AGENDA
REGULAR MEETING OF THE BIRMINGHAM PLANNING BOARD

WEDNESDAY APRIL 27, 2022

SUBJECT: 588 S. Old Woodward - Phoenicia – Special Land Use Permit Amendment, Final Site Plan & Design Review

Sheet No.:
A110
FIRST LEVEL
FLOOR PLAN

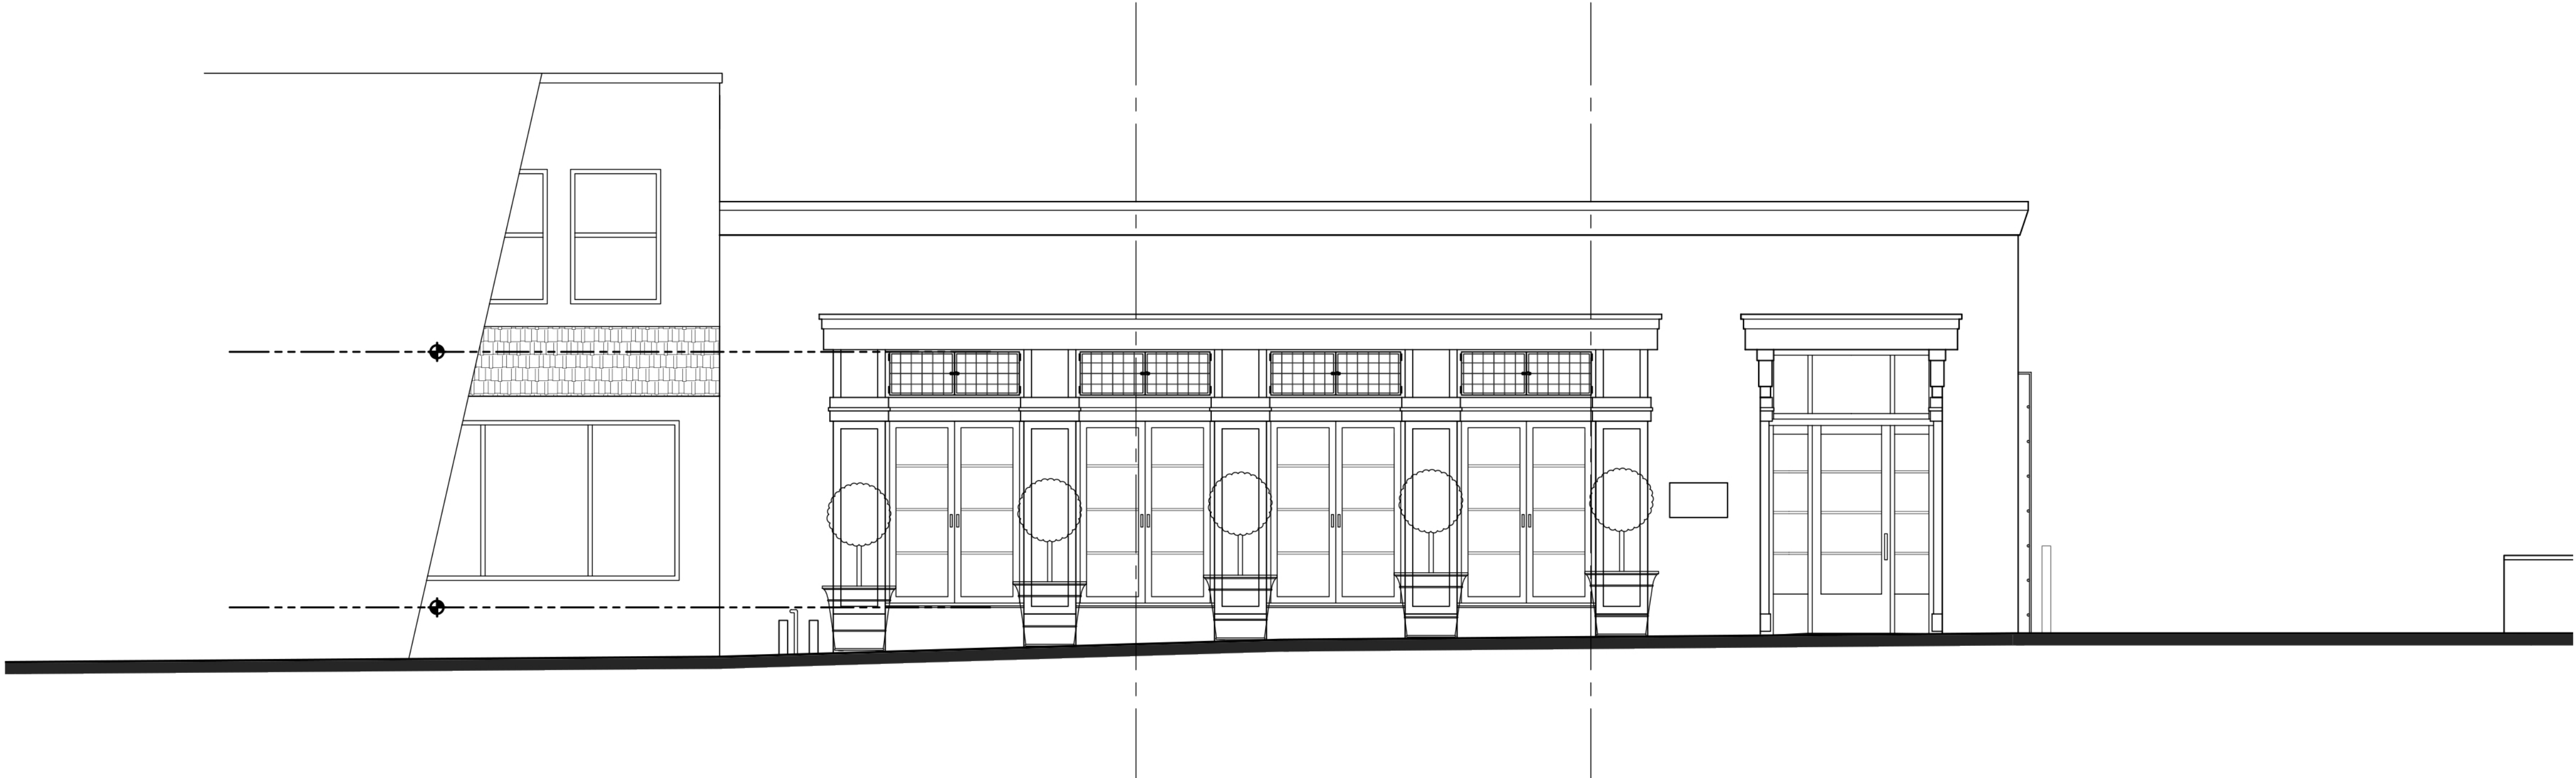
2. Parking Lot Screening – The parking lot is proposed to be screened from S. Old Woodward with 36 inch high Taxus Moon or Hatfield landscaping spaced 18 inches on center. This is a change from the current masonry screenwall. Article 4, Section 4.54(C)(3)(d) of the Zoning Ordinance enables the Planning Board to approve the use of evergreen screening in place of a masonry wall. **The Planning Division recommends the Planning Board approve of the proposed evergreen screening.**
The existing 6 foot masonry screenwall on the west side of the property will continue to screen the parking lot from the residential zone, satisfying parking lot screening requirements for parking lots adjacent to residential zones of Article 4, Section 4.54(B)(7).

4. Landscaping – The applicant has indicated additional landscaping surrounding the building and parking area. As previously mentioned, 36 inch high Taxus Moon or Hatfields will be used to screen three rows of parking from S. Old Woodward. Each row of screening landscaping along S. Old Woodward will be accompanied With a Frontier Hybrid Elm canopy tree 3 to 3.5 inches in caliper.
The building will retain the northern elevation's existing hydrangea vines on the wall trellises. The site plan also indicates expanded landscaping along the north elevation buffering the parking from the building with 120 vinca groundcover

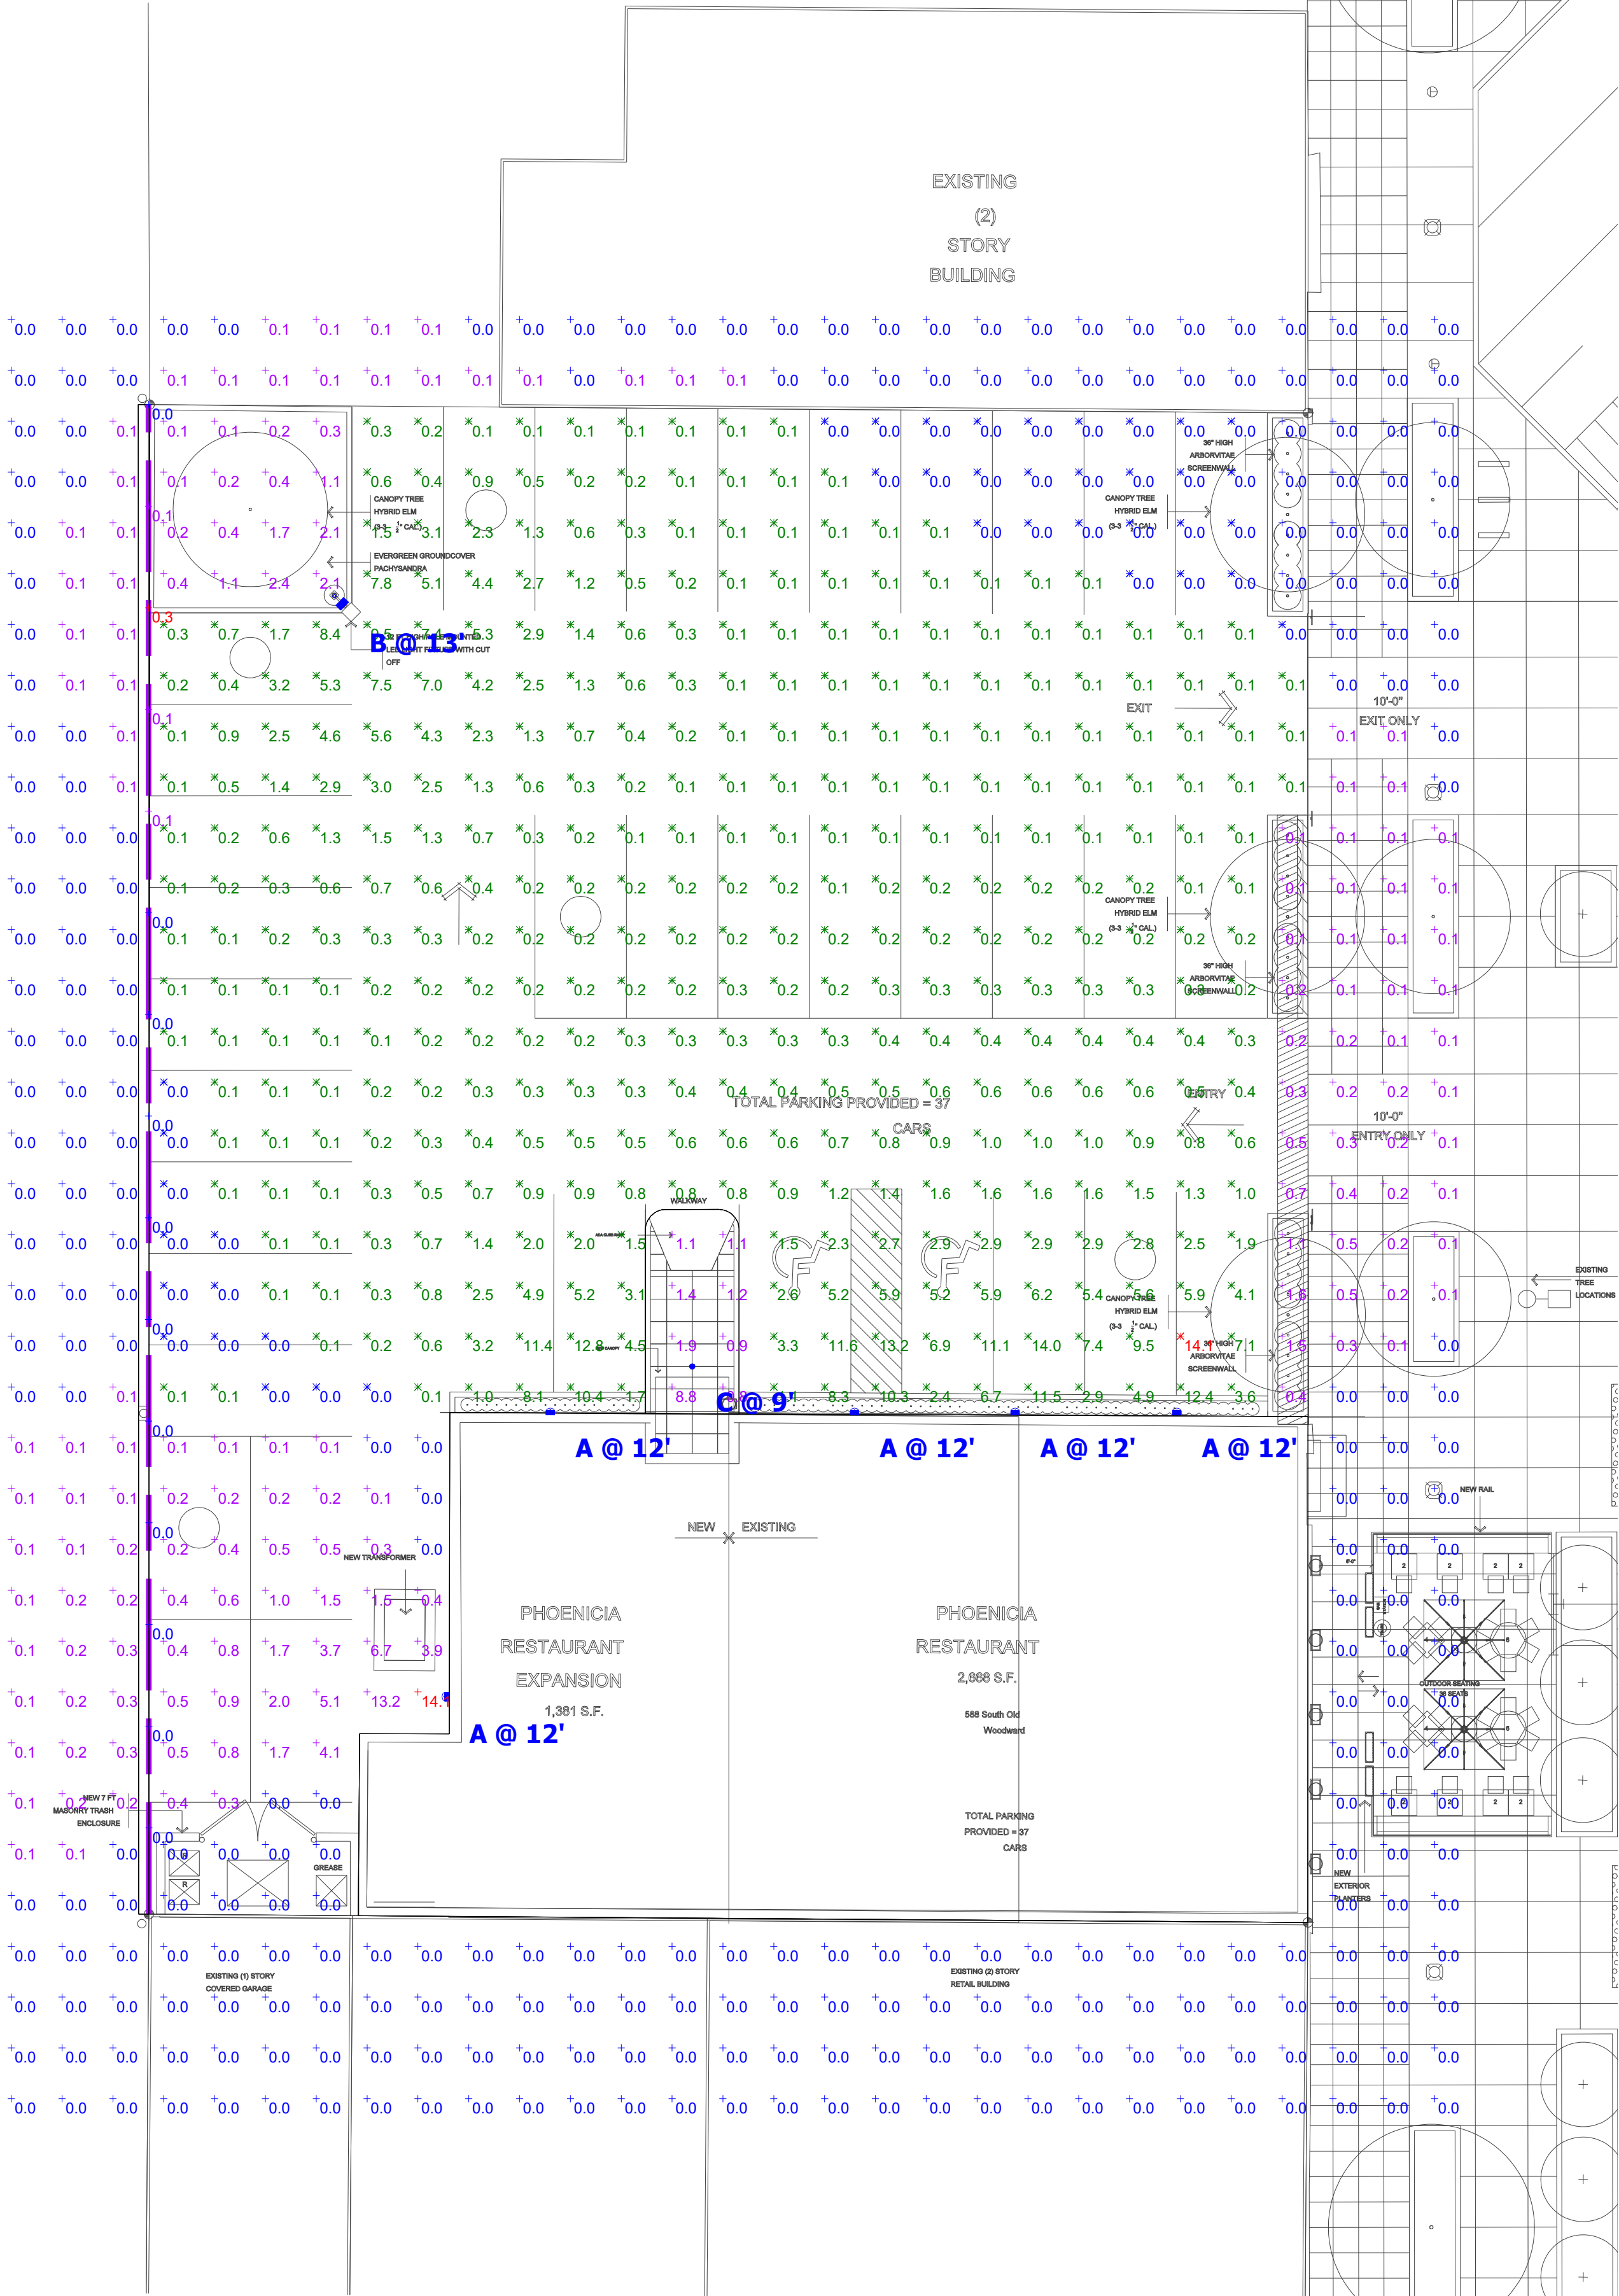
ratio of 20:1. The current ratio is 95:1, therefore the applicant must update their photometric plan to satisfy the foot candle requirements for parking lot circulation areas.
